Rainbow Hills Water Main Replacement Project
Solicitation Number: CO-00424
Job No.: 20-7009

ADDENDUM I
September 15, 2021

RAINBOW HILLS WATER MAIN REPLACEMENT SAWS WATER WORK DEAD END ELIMINATION DE2 - WESTPOND DRIVE

DRAWN: SN DESIGN: JP CHECK: LC SHEET NO : 33 OF 74

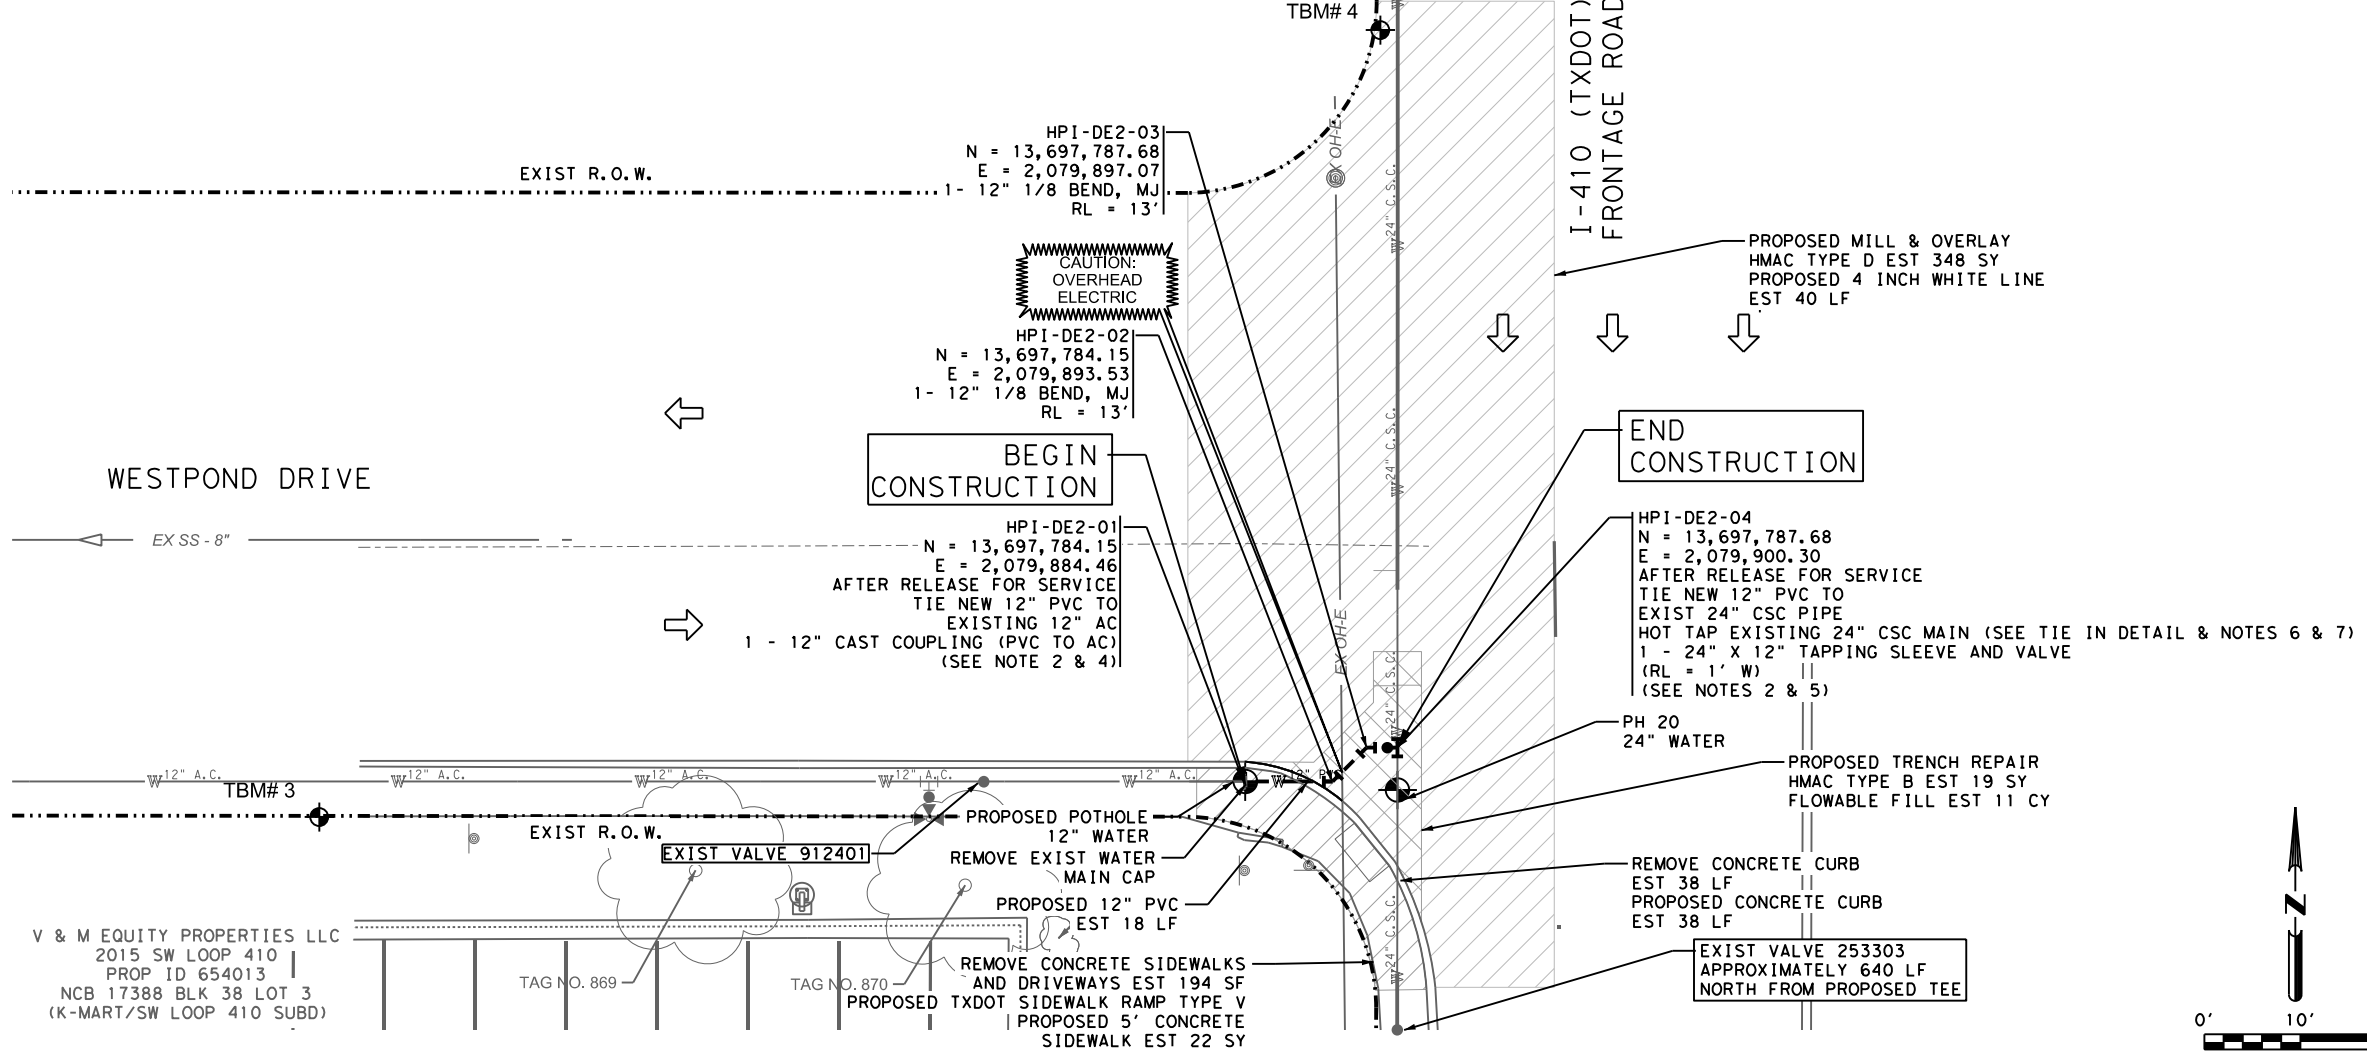
Replace Sheet 33 of 74 with attached Sheet 33 of 74 in its entirety. Flowable fill and 2" mill and overlay were revised.
